STATE OF NORTH CAROLINA
DEPARTMENT OF TRANSPORTATION

June 2, 2008

Subject: **Revised Impact Information for Section 404 Nationwide Permit 14 and Section 401 Water Quality Certification Application.** Widening of US 70 from the Rowan/Iredell County Line to SR 1001(Amity Hill Road) in Rowan County. NCDOT Division 9, State Project No. 8.1631801, WBS No. 34517.1.1, T.I.P. No. R-2911B.

PROJECT REFERENCE NO. R-2911B	SHEET NO. 14
R/W SHEET NO.	HYDRAULICS ENGINEER
ROADWAY DESIGN ENGINEER	
PRELIMINARY PLANS DO NOT USE FOR CONSTRUCTION	
Permit Drawing Sheet 9 of 11

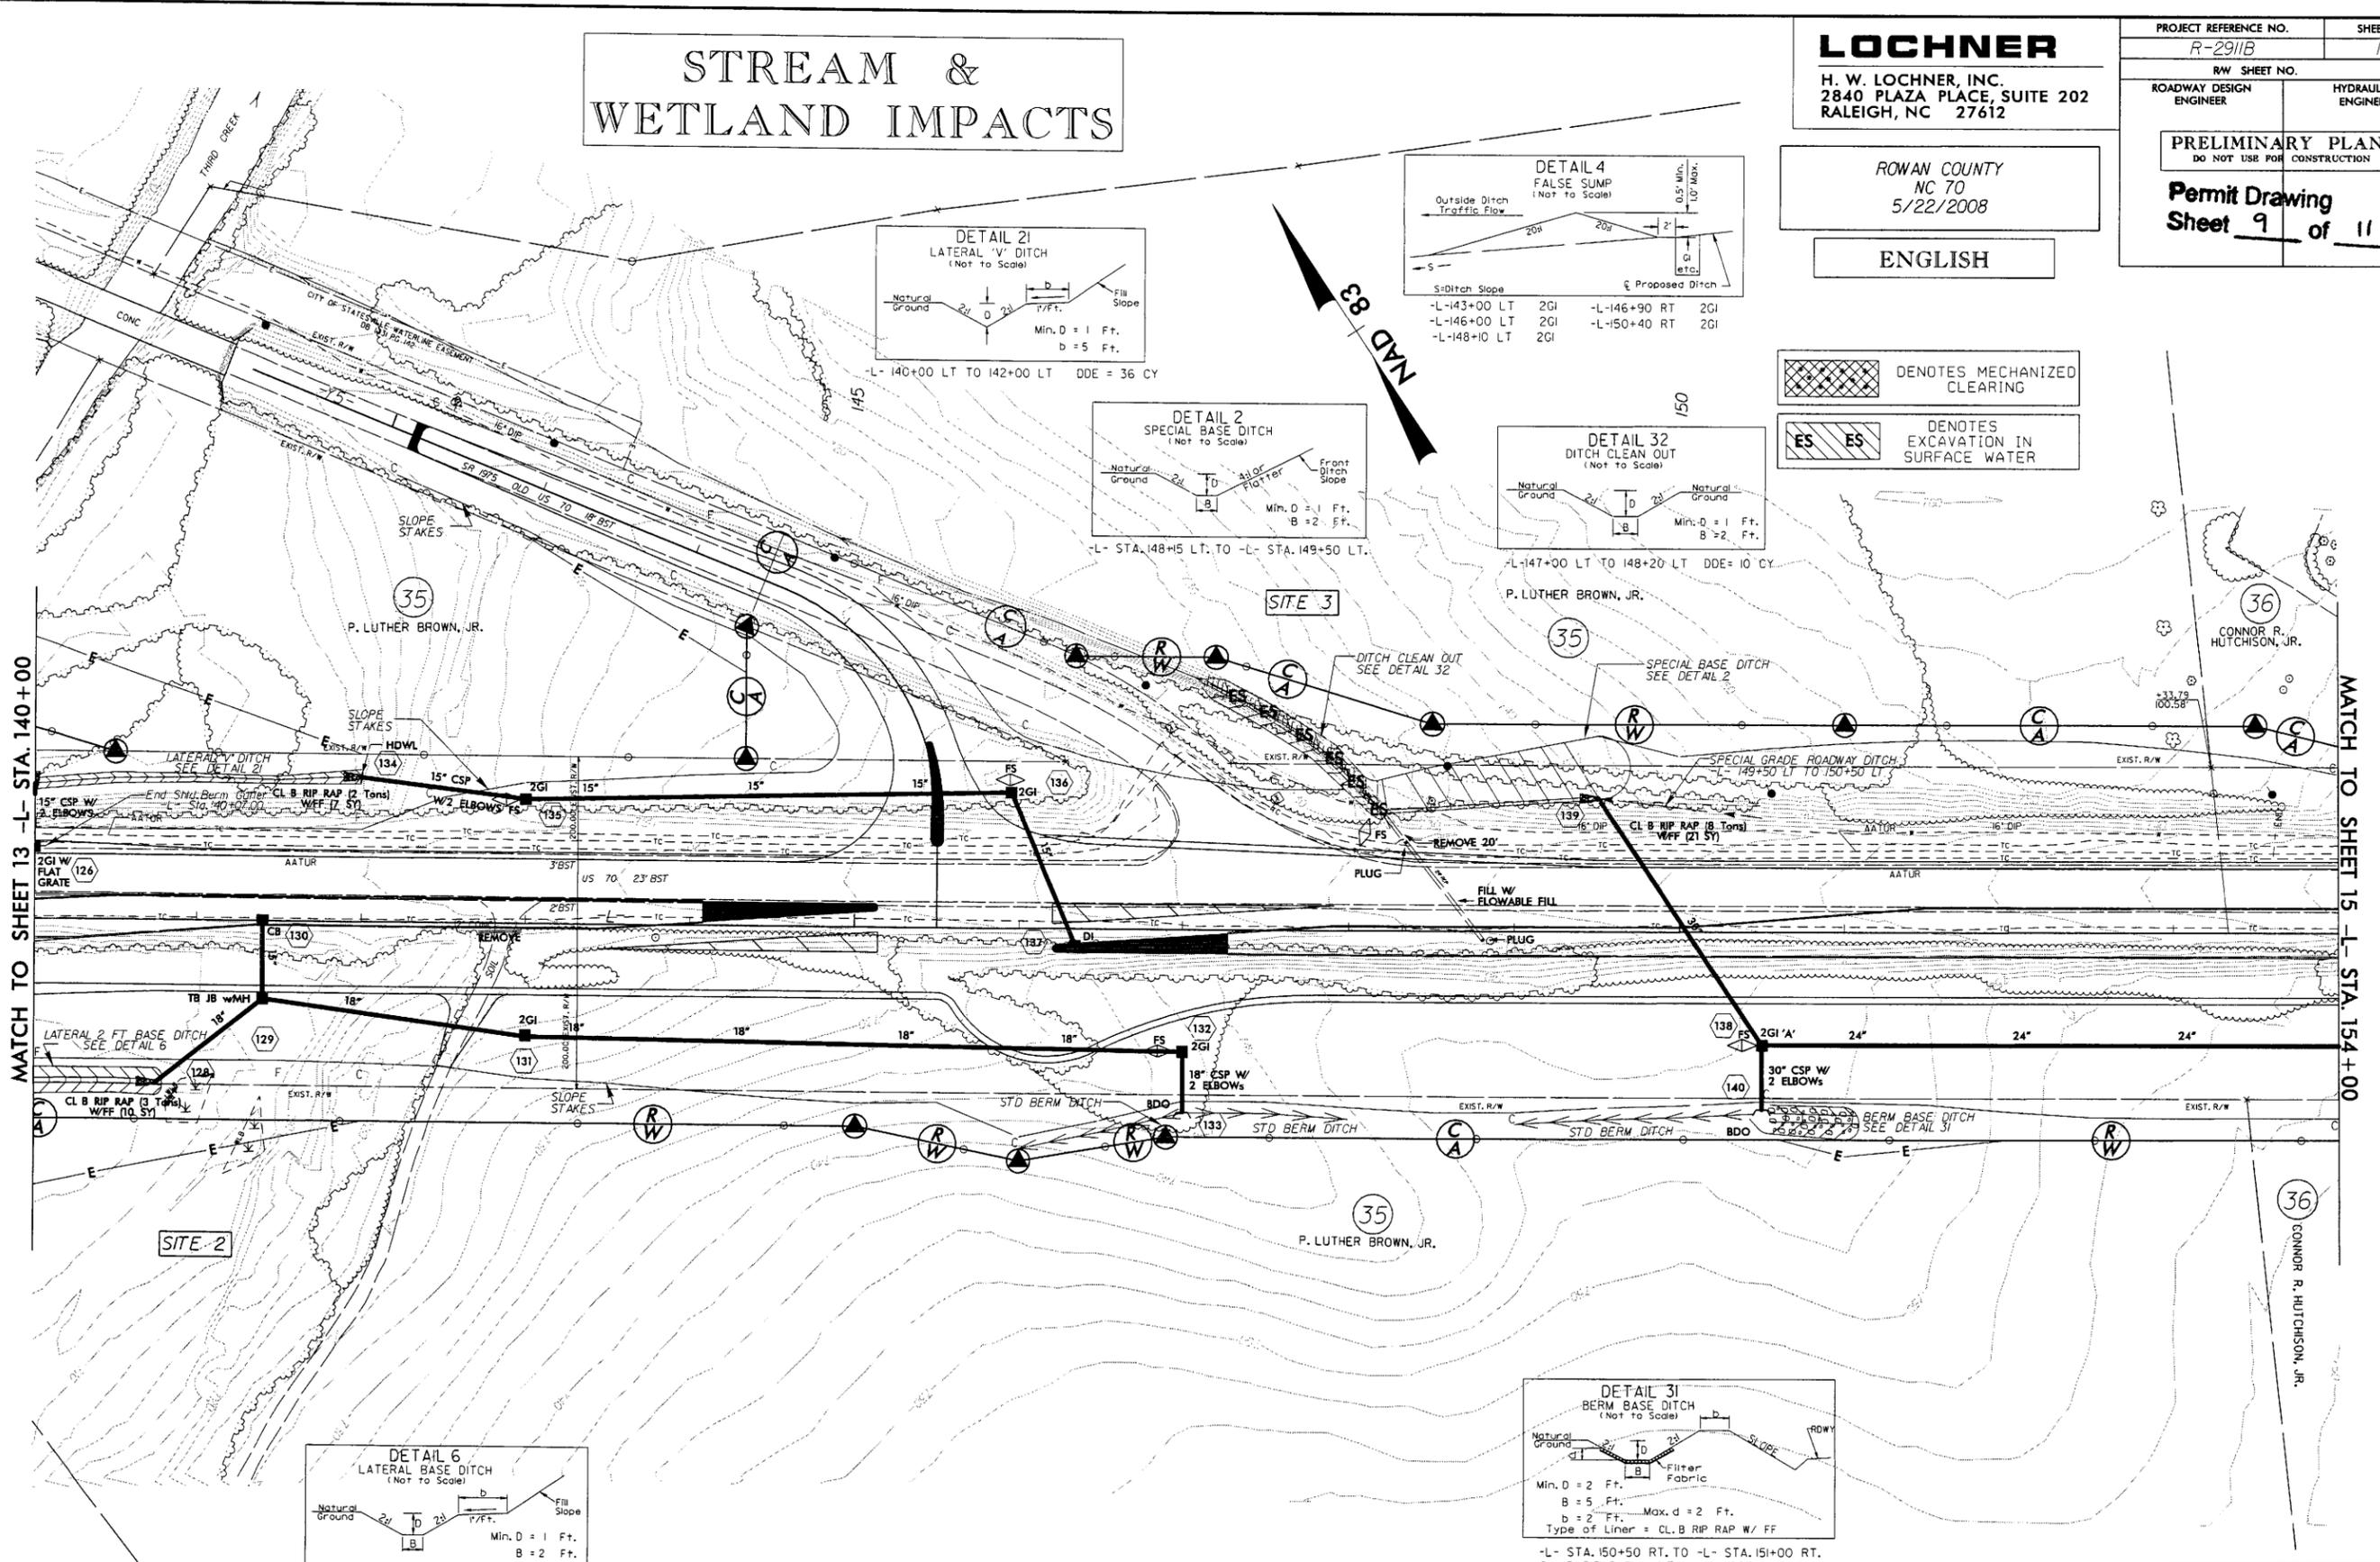
There will be approximately 137 linear feet of permanent jurisdictional stream impacts to UT to Third Creek. These impacts are the result of the construction of a lateral V ditch.

PROJECT REFERENCE NO. R-2911B	SHEET NO. 15
R/W SHEET NO.	HYDRAULICS ENGINEER
ROADWAY DESIGN ENGINEER	HYDRAULICS ENGINEER
PRELIMINARY PLANS DO NOT USE FOR CONSTRUCTION	
Permit Drawing Sheet 10 of 11

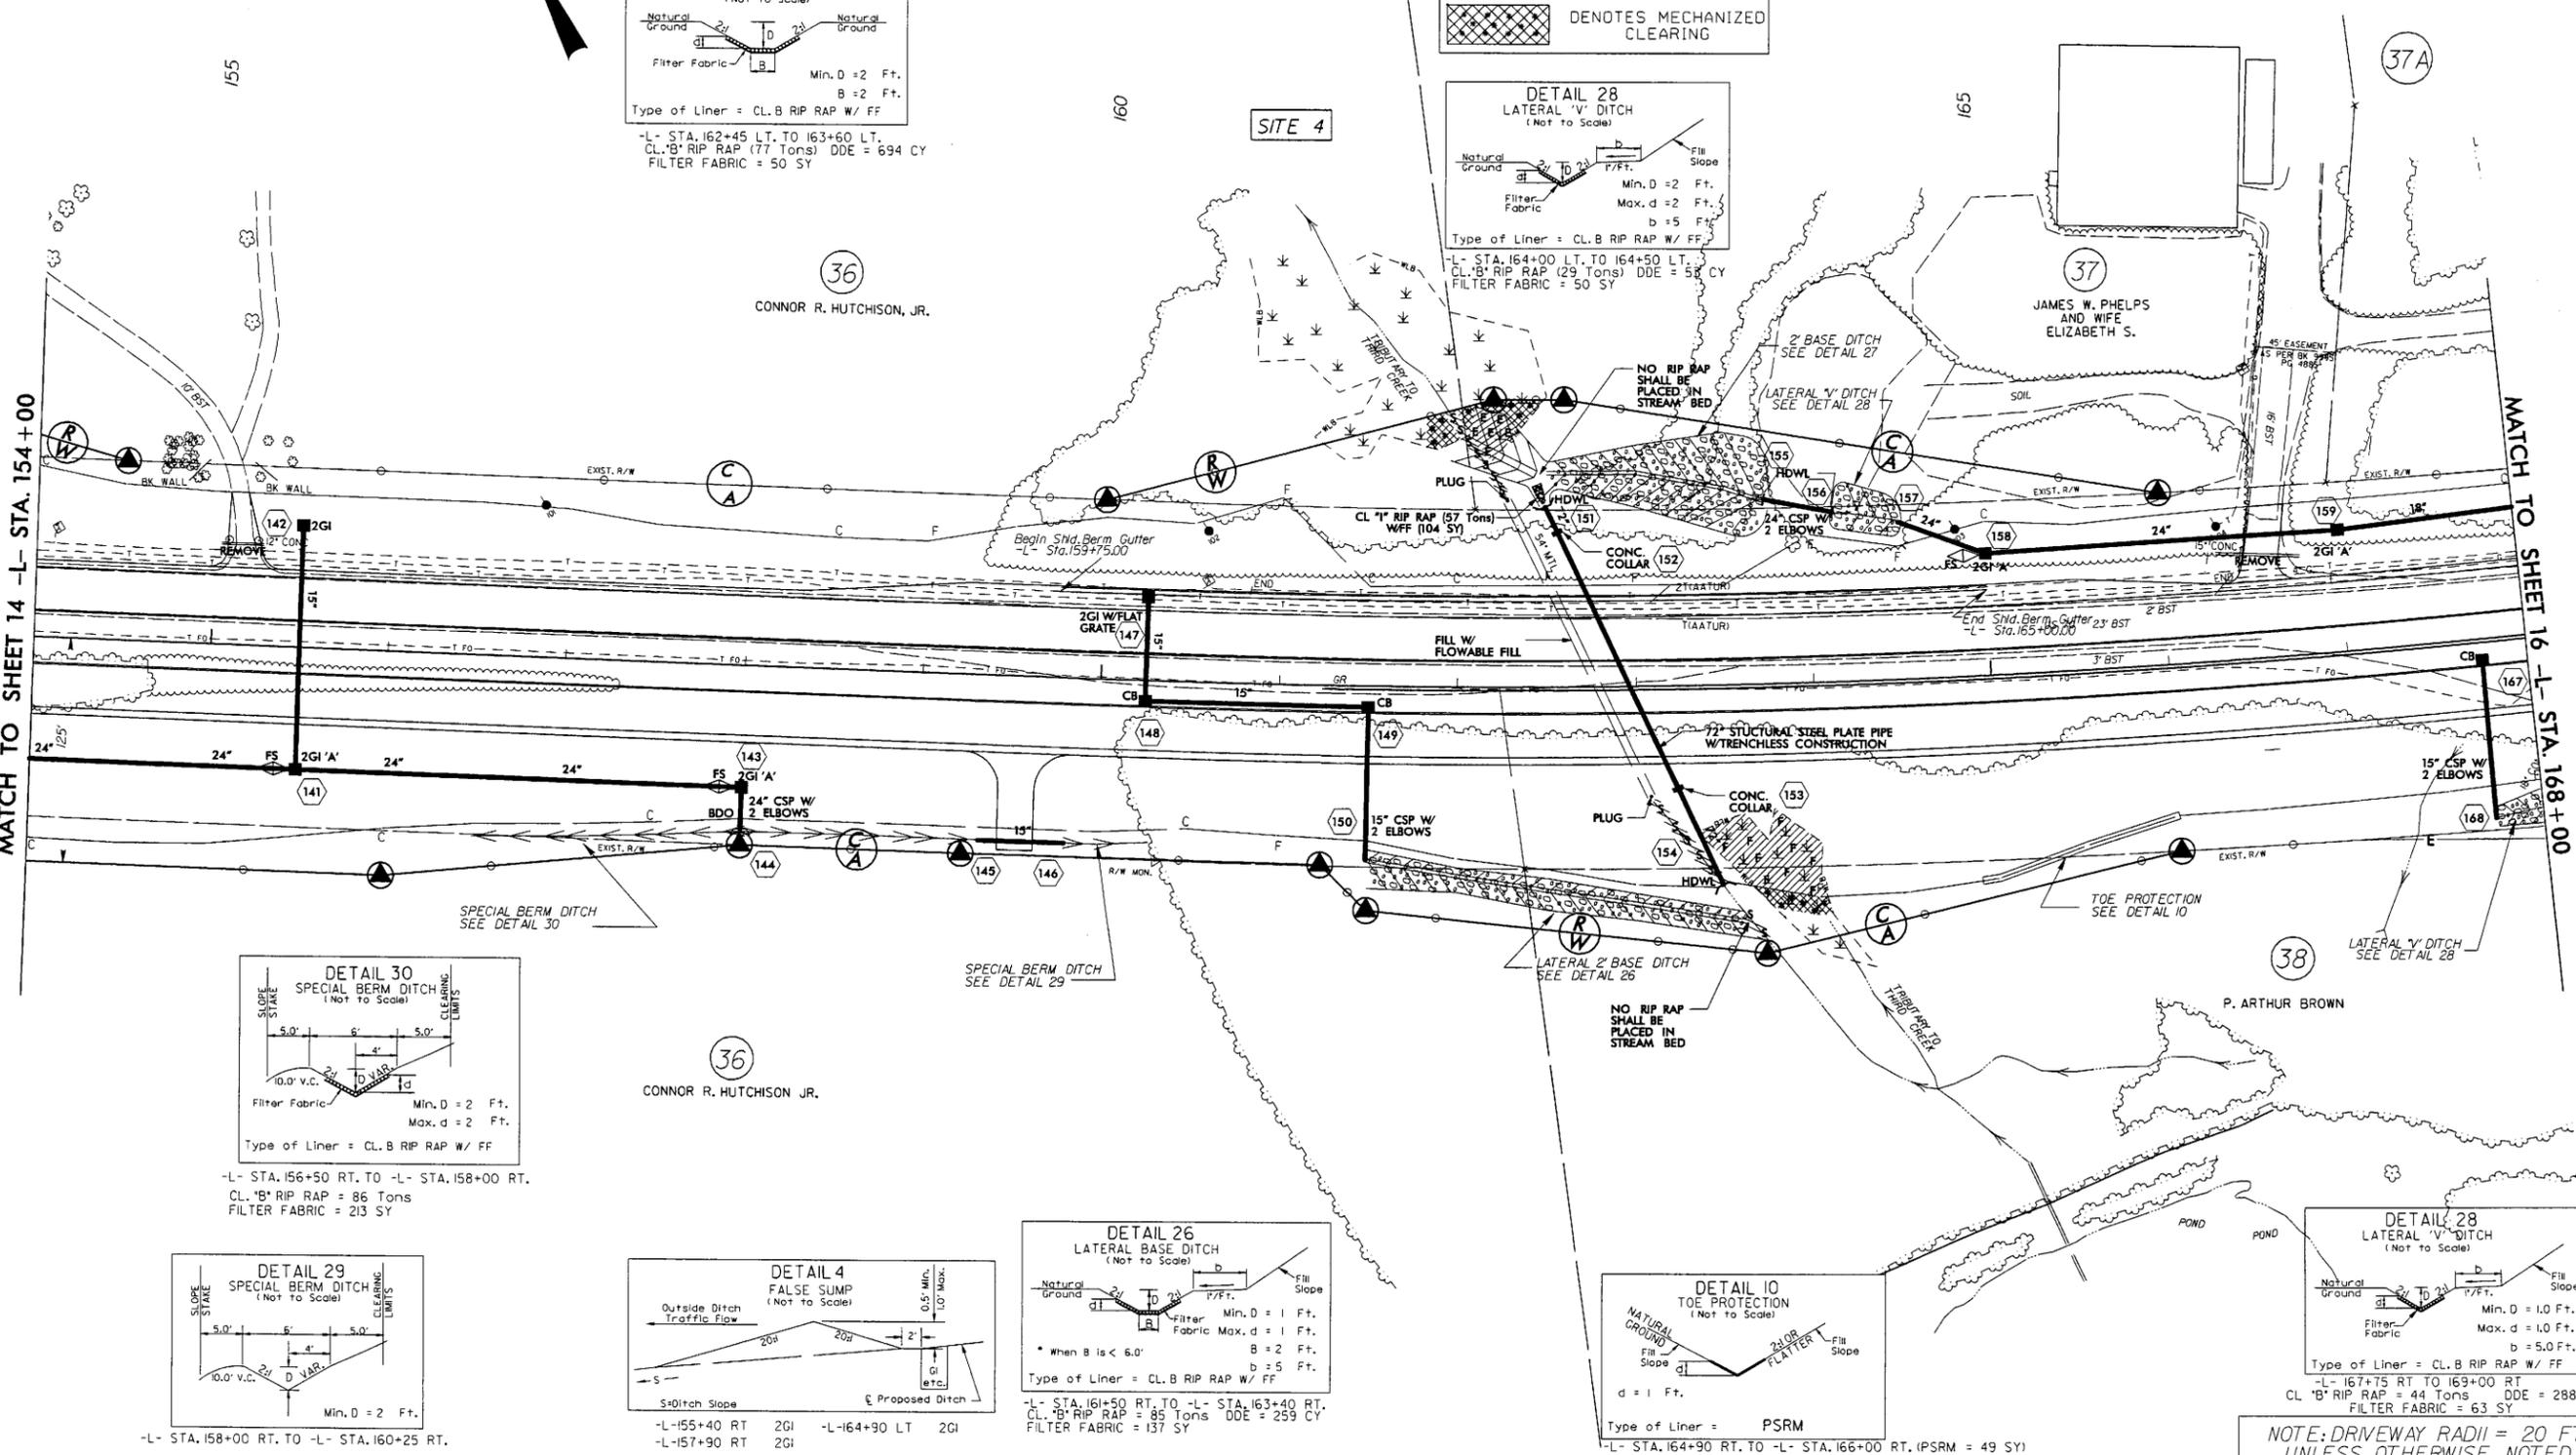
The wetland impacts at this site have not changed from the original permit application. However, the permanent surface water impacts have been revised. Permanent surface water impacts to this site will be 145 linear feet to UT to Third Creek. All wetland and stream impacts associated with Site 4 are the result of the construction of a lateral V ditch and the installation of the 72-inch steel plate pipe.
